Americans with Disabilities Act Transition Plan Lower Keys - Part 1

Volume 3 of 4

Monroe County

**ADA Accessibility Services
Volume 3 of 4
Lower Keys – Part 1**

<p>3.3 PHOTOS: PARKING AND EXTERIOR ROUTES</p>

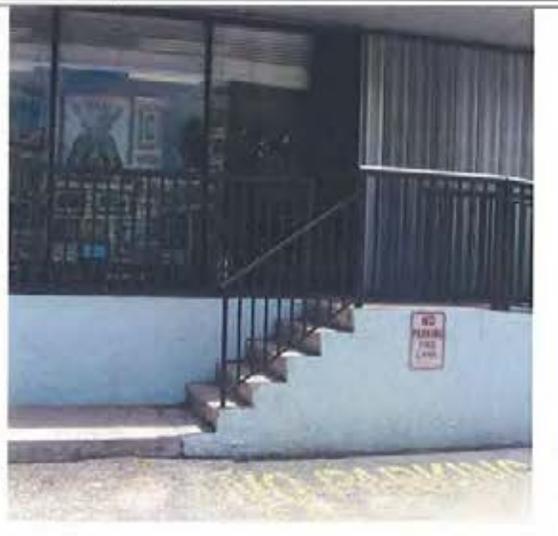
<p>emergency egress.</p> <ul style="list-style-type: none"> ⊗ At the top of the ramp, the landing does not provide enough room to safely open the rear door with a latch-side approach. <p>There is a set of Steps near the ramp for the rear office door.</p> <ul style="list-style-type: none"> ⊗ The handrail on the steps does not extend at the bottom or top. ⊗ The handrail is only on one side of the steps. 	<p>AS - Reconfigure the step handrails in accordance with FACBC 11-4.9.</p>
--	--

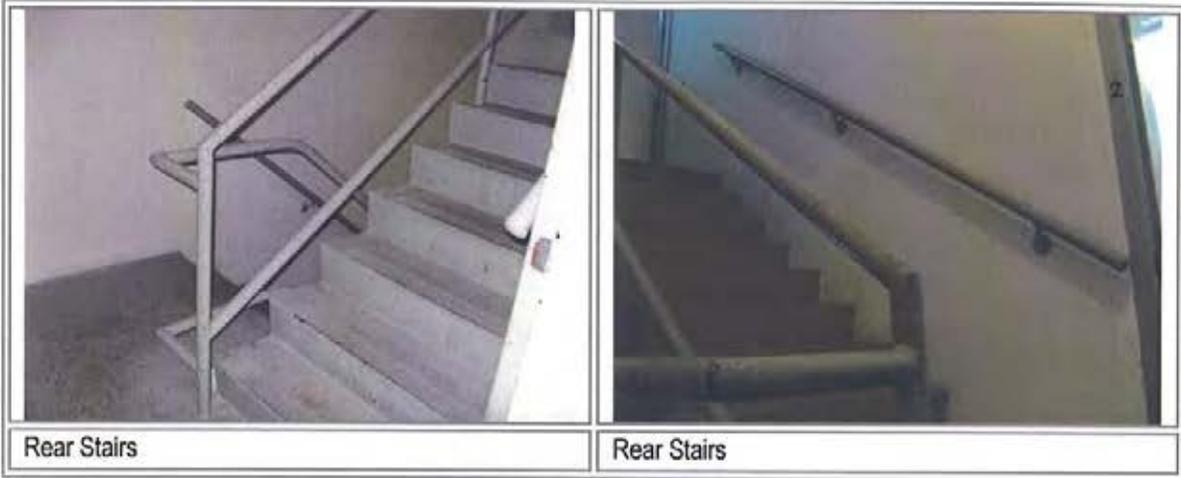
<p>The Jury Box is not accessible.</p> <ul style="list-style-type: none"> ⊗ It has two levels and requires at least one riser must be used. ⊗ There is no area for a wheel chair other than directly in front of Jury Box. 	<p>AS - Add ramp to part of Jury Box per ADAAG 4.2.4 ASS - Add a lift to one side of the Jury Box.</p>
<ul style="list-style-type: none"> ⊗ The Witness Stand requires stepping up one riser and is not accessible. There is no provision for a wheelchair. 	<p>AS - Make one level, or add ramp per ADAAG 4.3.8</p>
<ul style="list-style-type: none"> ⊗ The door from the Judge's Bench to the chamber area has 27" clear and is not accessible. ⊗ There is no accessible route from the courtroom to the jury room. Opening behind bench is 35". ⊗ The door to the jury room is 25" clear. 	<p>TI - This item cannot be corrected within the confines of the existing structure.</p>
